# UNITED STATES PATENT AND TRADEMARK OFFICE

APPLICATION NO.	FILING DATE	FIRST NAMED INVENTOR	ATTORNEY DOCKET NO.	CONFIRMATION NO.
10/672,772	09/26/2003	Mary Anne Alvin	2003PI4907US	9698

# Office Action Summary

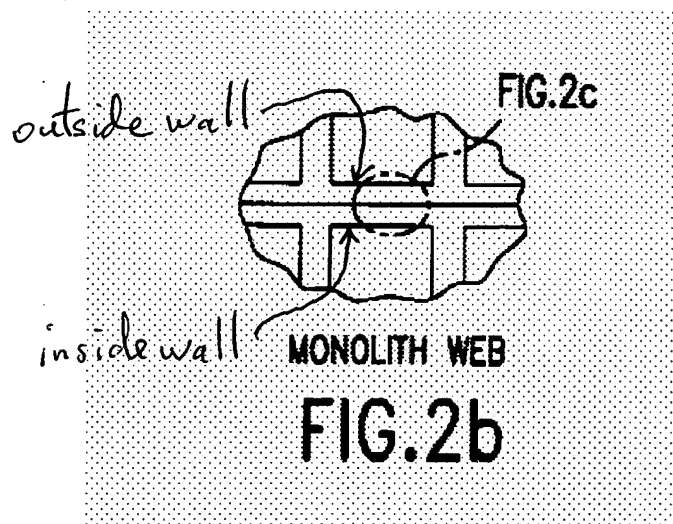
Claims 1 and 11 are rejected under 35 U.S.C. 102(b) as being anticipated by McCarty et al (US 6,015,285). See figure 2b reproduced below which shows a duct being formed by inside walls and outside walls. Both the inside and outside walls are lined with a barrier layer, and a catalyst is coated over the barrier layer.
